Addendum No. 3

September 10, 2021

Project: San Fernando Regional Park Infiltration Project

**Attachment 4: Revisions to Diversion Pipe Plan and
Profile from Glenoaks Boulevard**

DWG NO.
C-06
SHEET NO.
7
OF
46

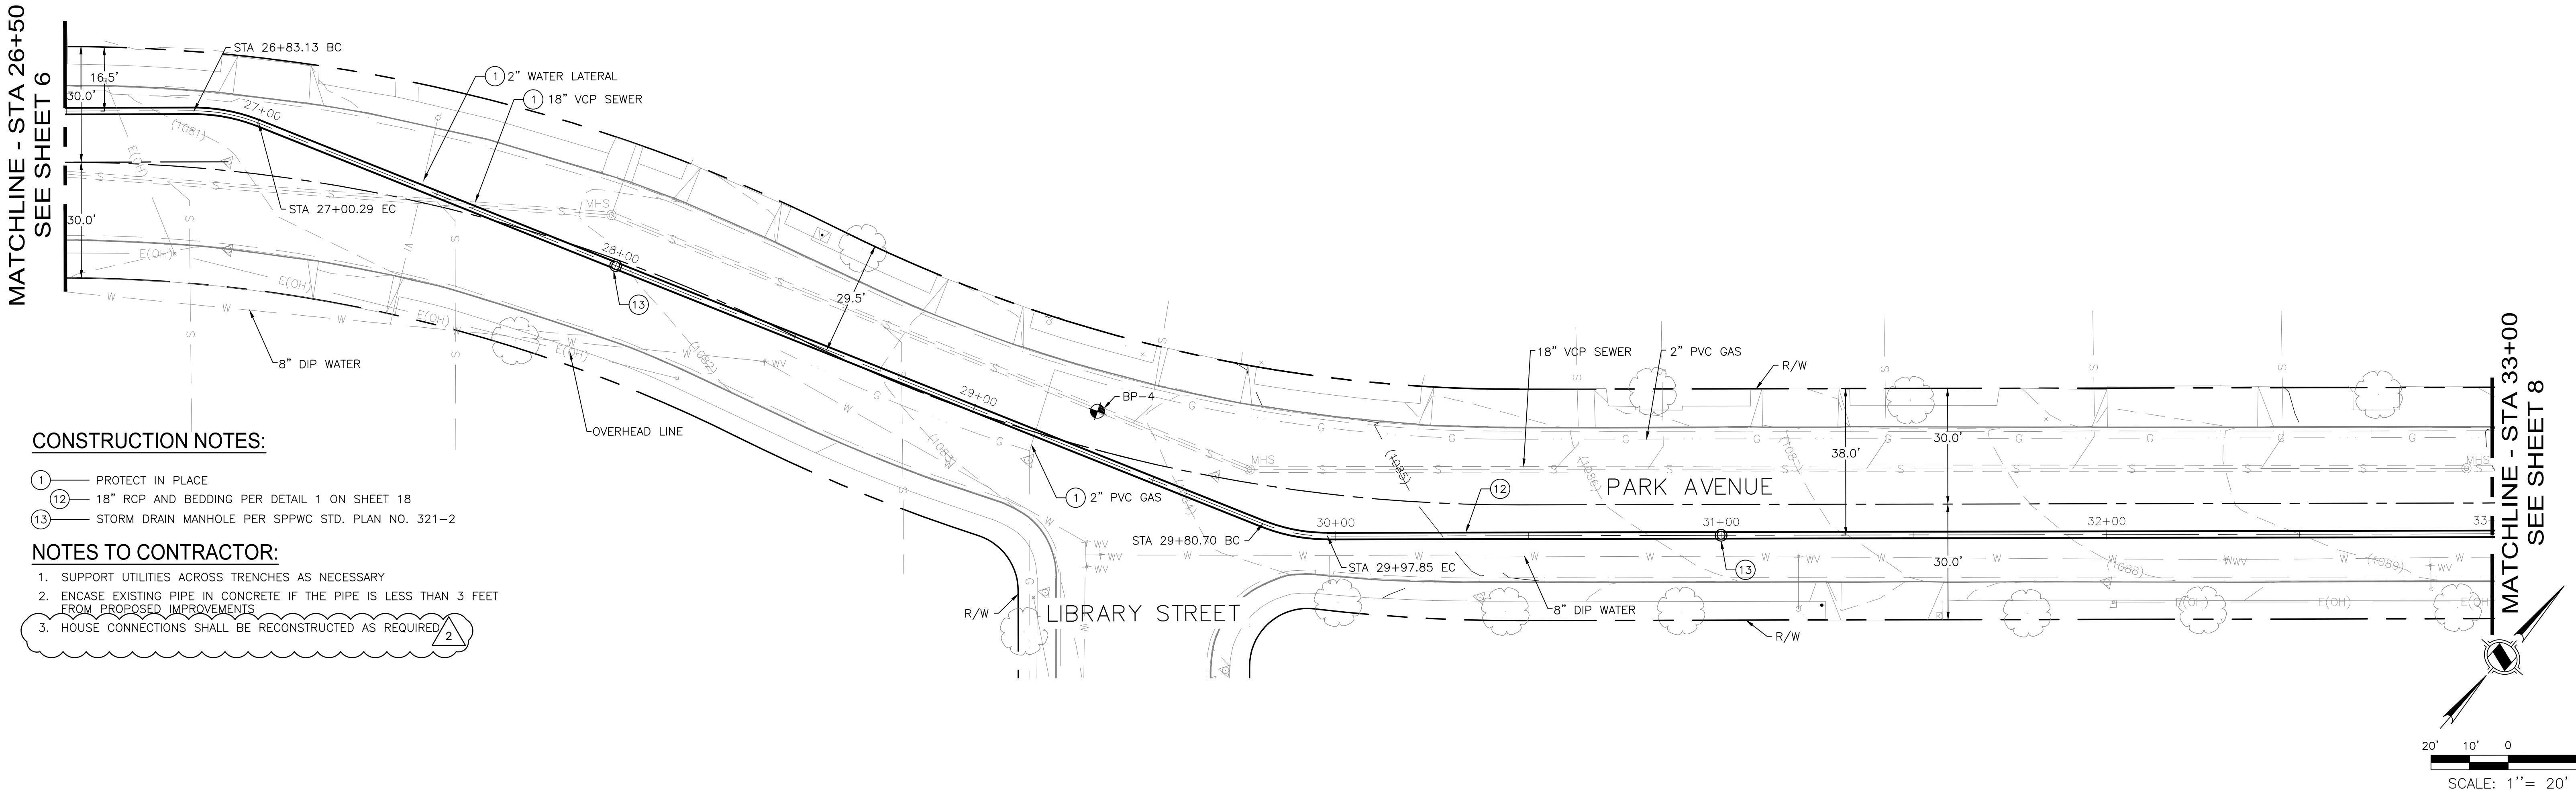
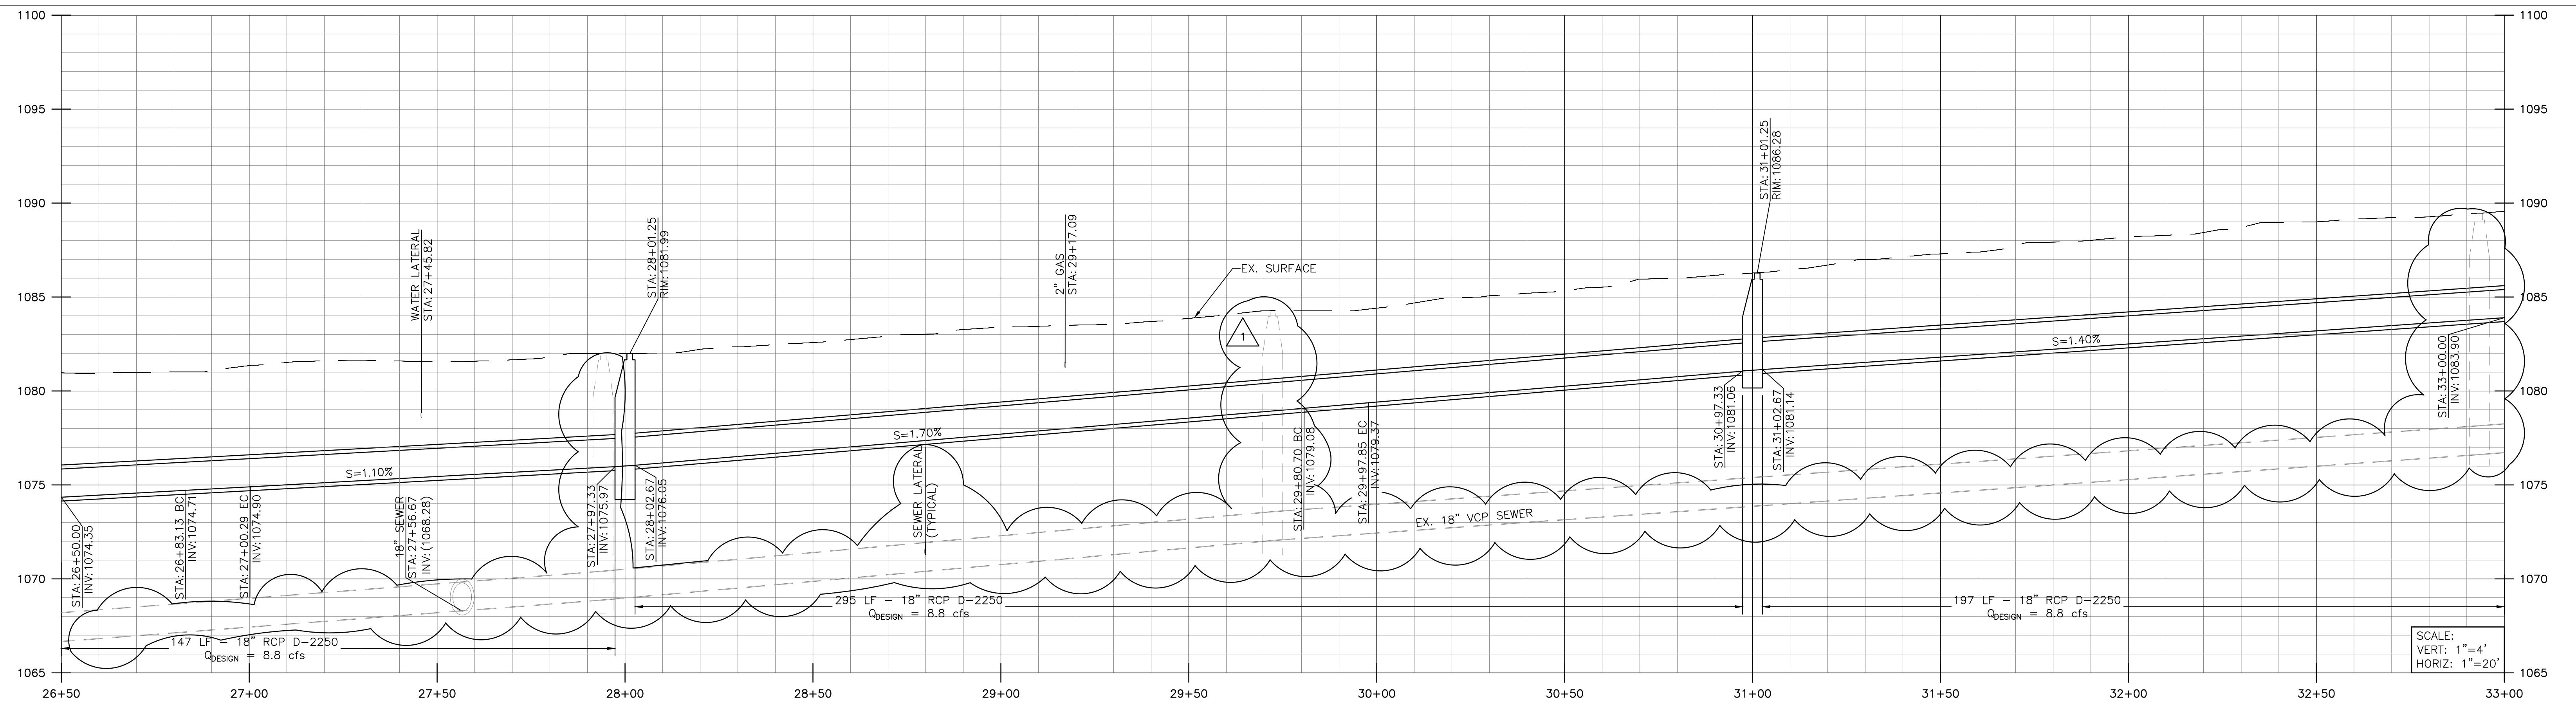
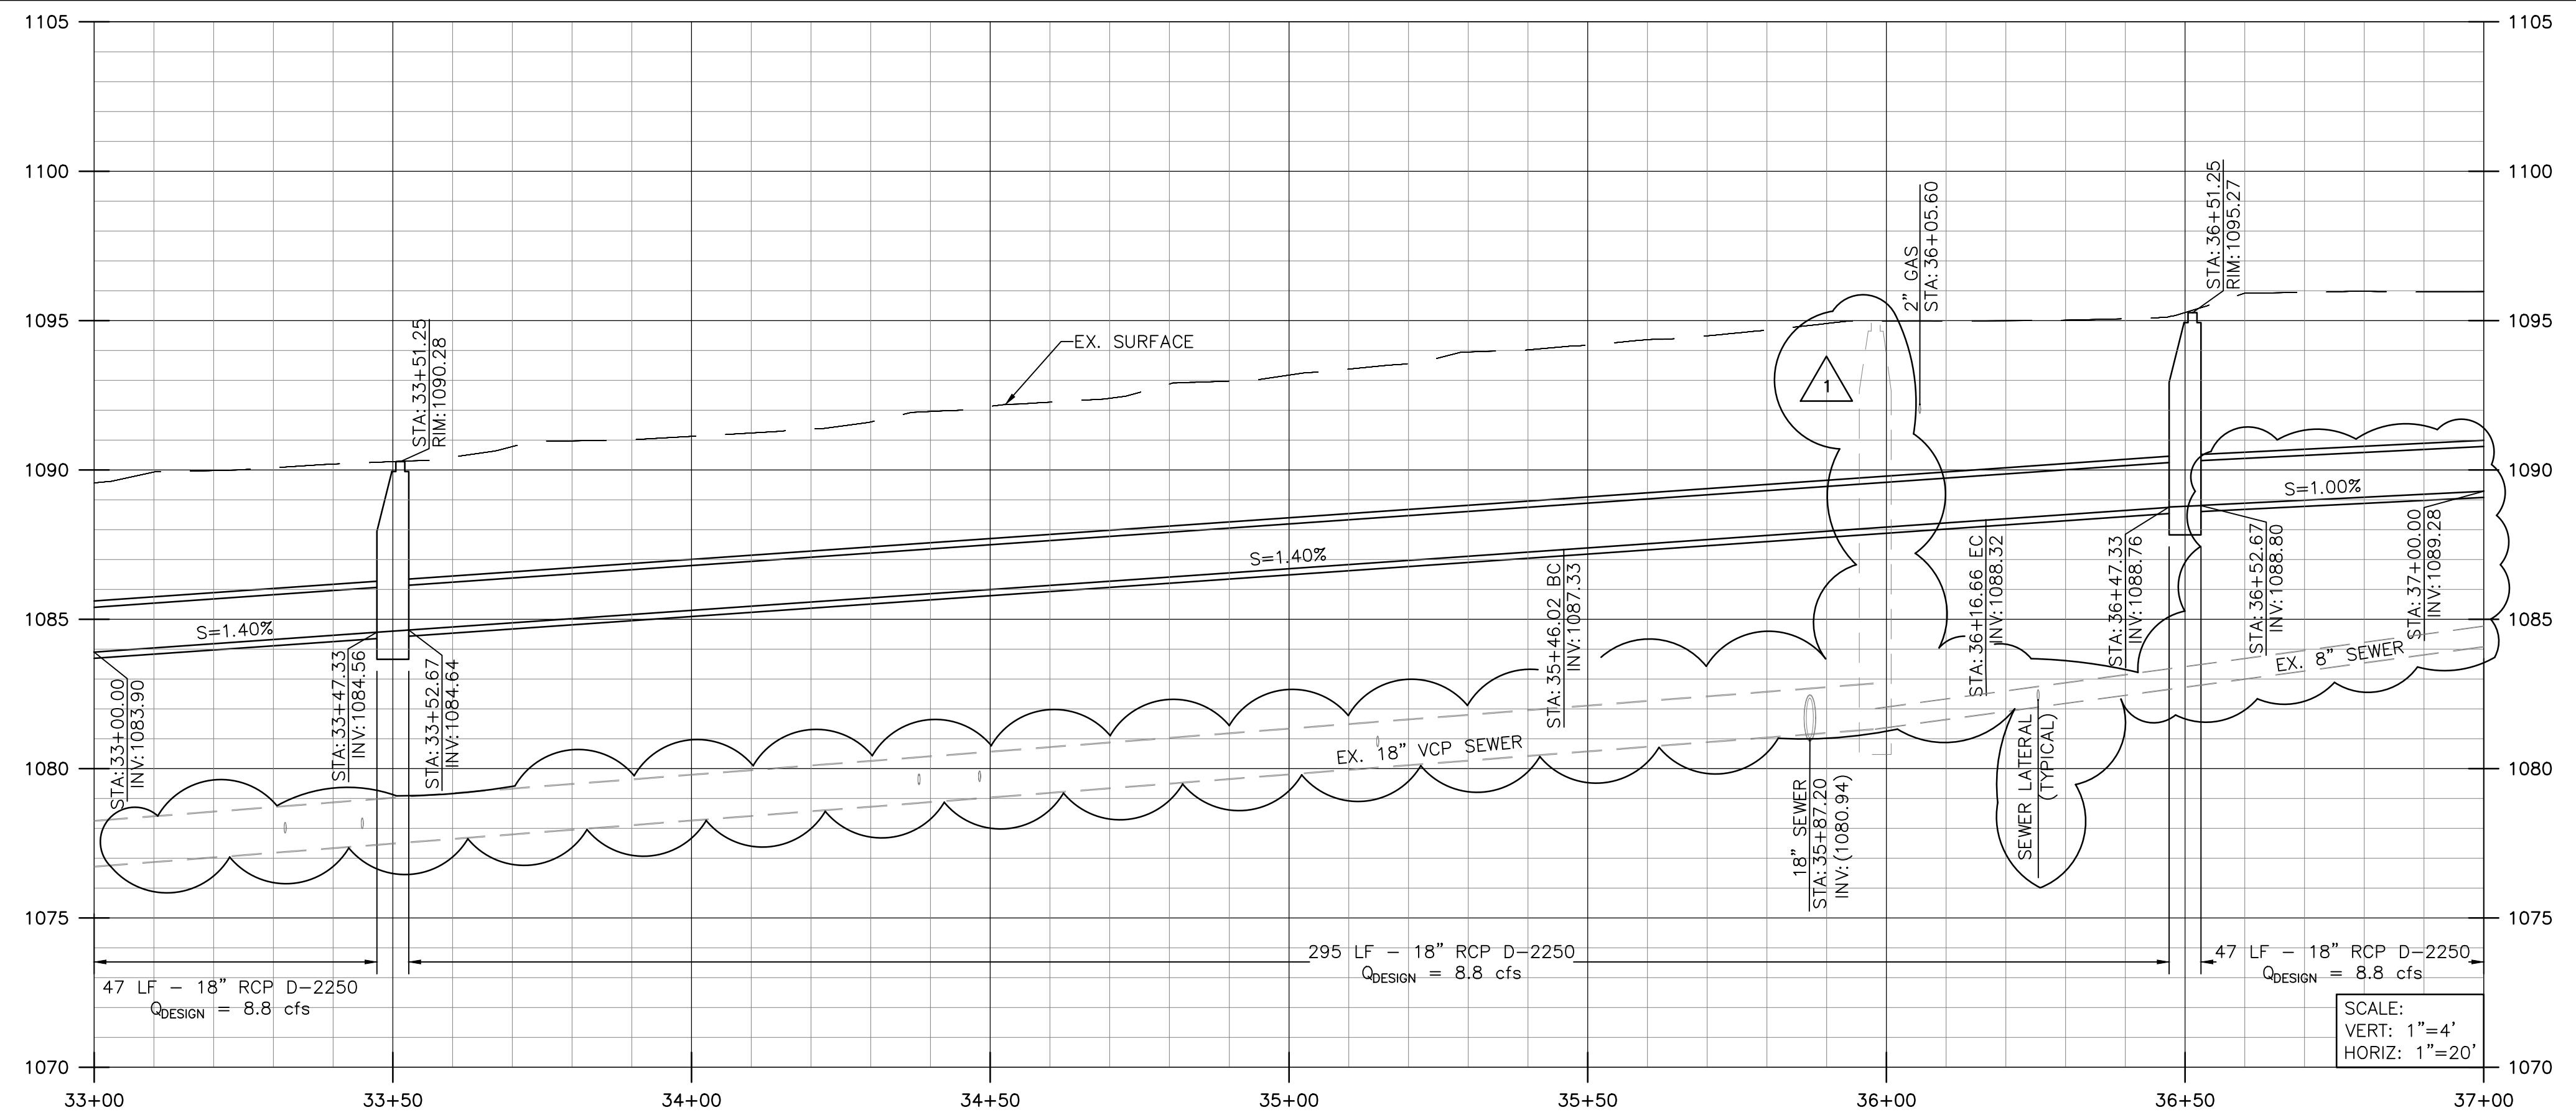
REV.	DATE	BY	DESCRIPTION	APP'D
1	9/7/21	TT	ADDED EX. SEWER LINE TO PROFILE; REVISED PIPE INVERT/SLOPE	
2	9/10/21	TT	ADDED HOUSE CONNECTION NOTE UNDER NOTES TO CONTRACTOR

San Fernando Regional Park Infiltration Project
SAN FERNANDO RECREATION PARK AND FROM FIRST STREET TO GLEN OAKS BOULEVARD
LINE "B" STA 33+00 TO 37+00
PLAN AND PROFILE

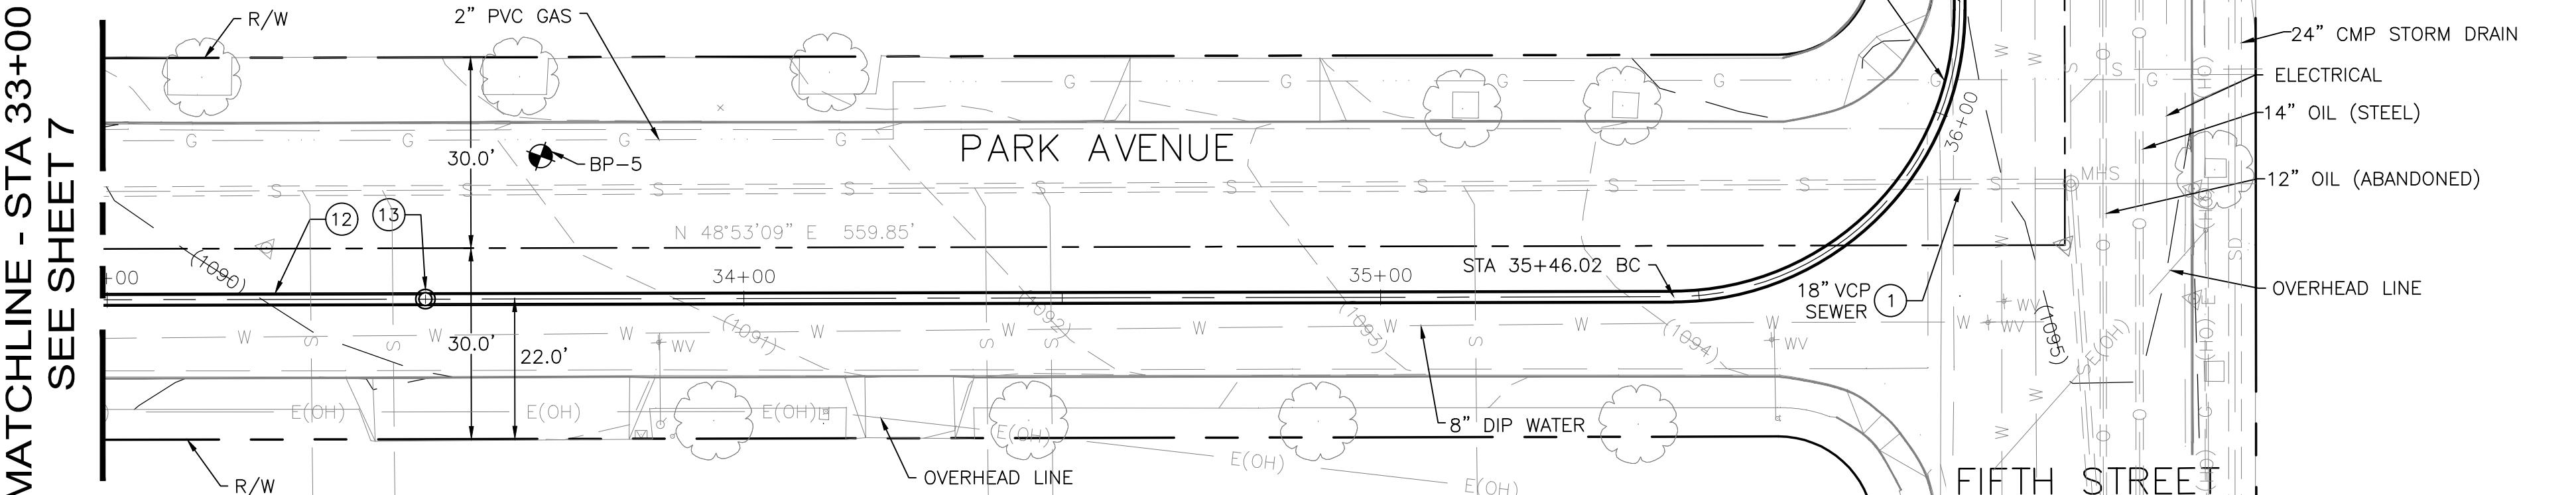
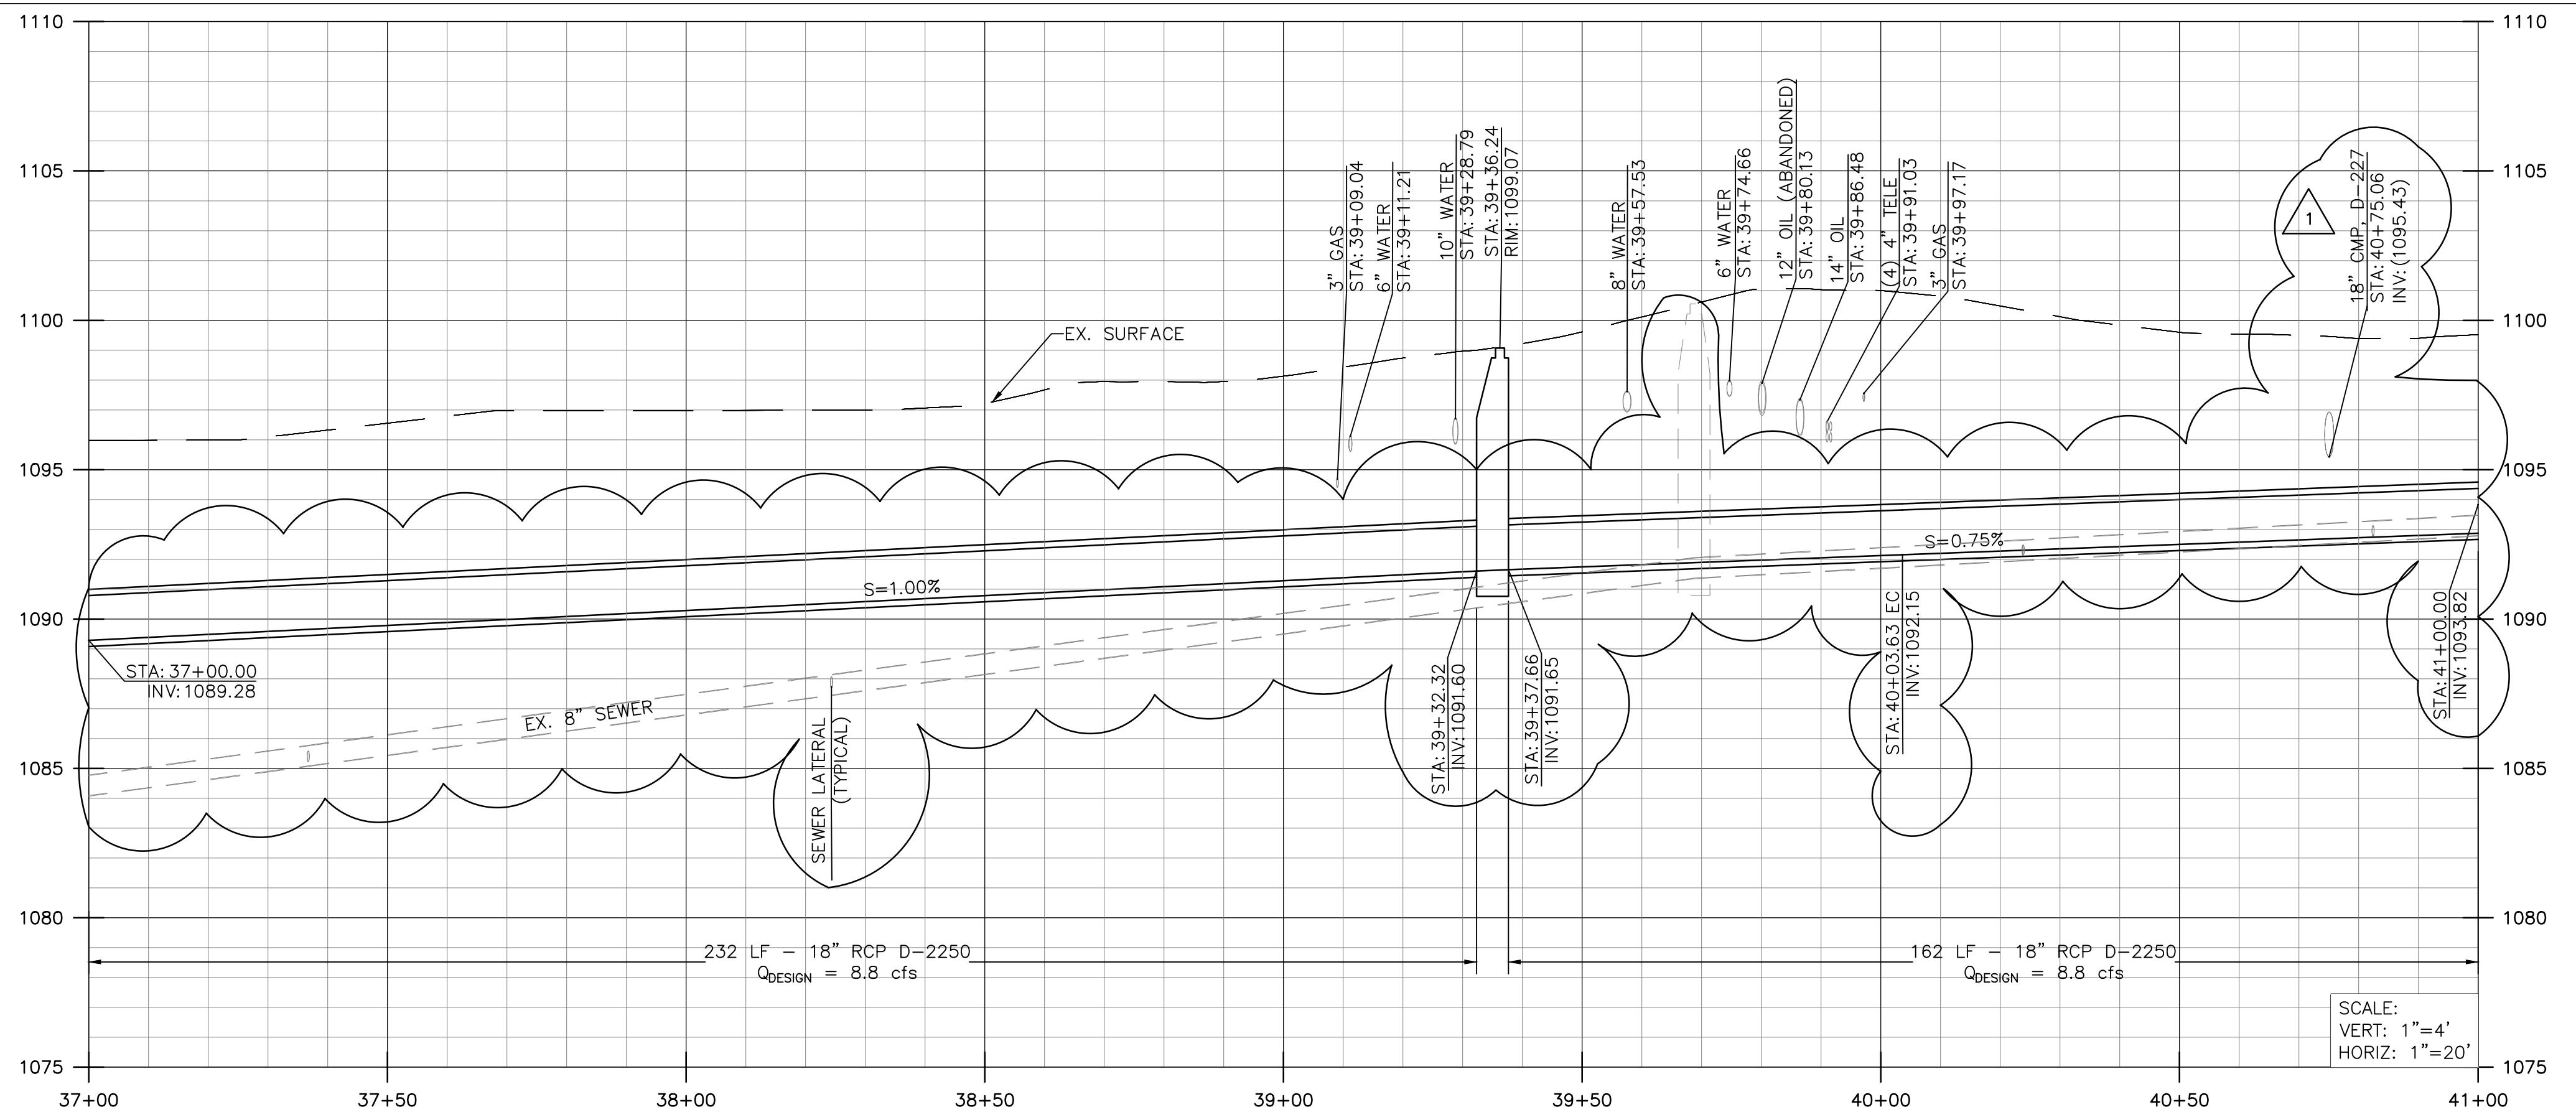
REV.	DATE	BY	DESCRIPTION	APP'D
1	9/7/21	TT	ADDED EX. SEWER LINE TO PROFILE; REVISED PIPE INVERT/SLOPE	
2	9/10/21	TT	ADDED HOUSE CONNECTION NOTE UNDER NOTES TO CONTRACTOR
